INITIAL FIRE SAFETY INSPECTION REPORT

MM Knit Wear (Extension Buildings)

RSC ID: 24162

Date: 8-Jun-2021 and 25-Aug-2021

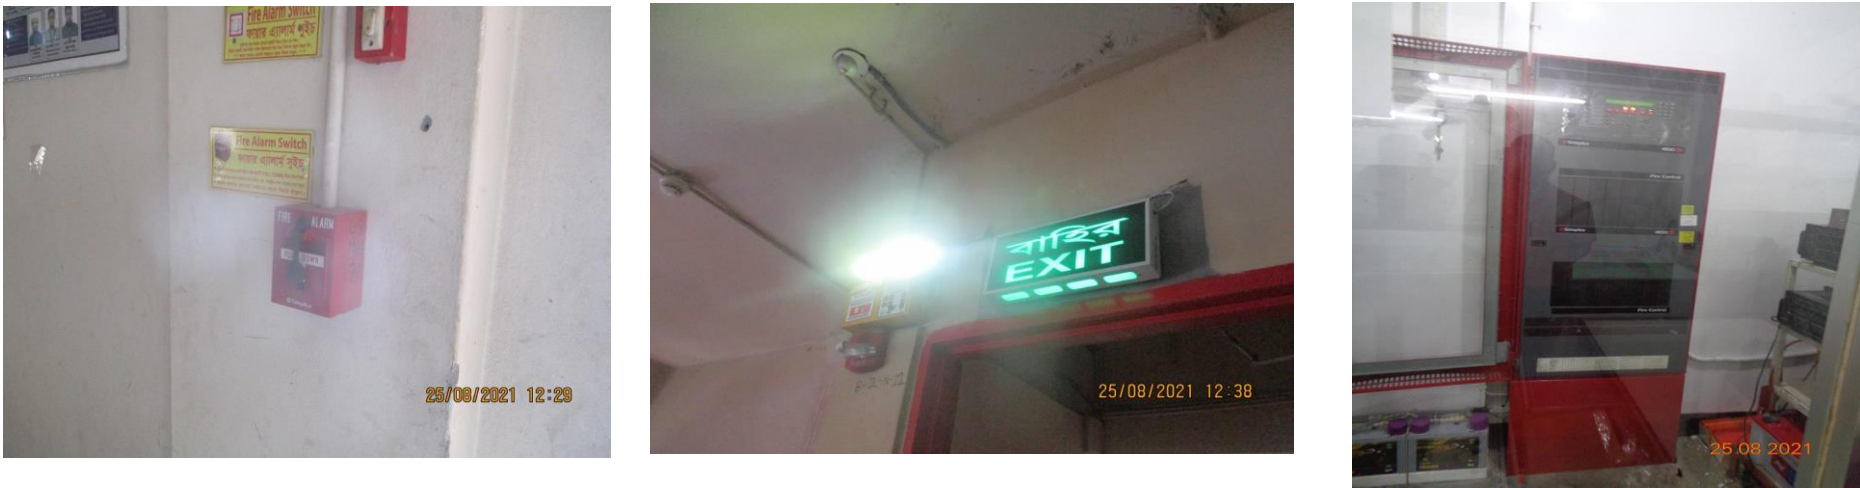
F- 68	Fire Rated Construction	Liquefied or compressed gas cylinder storage located within the factory. Location: Shed- 3	1. The storage building must be at least 3 meters away from any other building and boundaries. 2. The exterior walls of the building must have a fire resistance rating of 3 hours using noncombustible construction. 3. Doors and other openings in the exterior walls must be protected with suitable closing devices having a fire protection rating of 3 hours. 4. The building is to be used for no other purpose than the storage of LPG/CNG cylinders. 5. The building must be mechanically ventilated to control the accumulation of flammable vapors. 6. The installations must be approved and accepted by the requirements of the AHJ, Gas supply company regulations, manufacturers/supplier's instructions/guidance, Chief Inspector of Boiler (CIOB) and Chief Inspector of Explosives Bangladesh (CIEB).	Within 1 Month
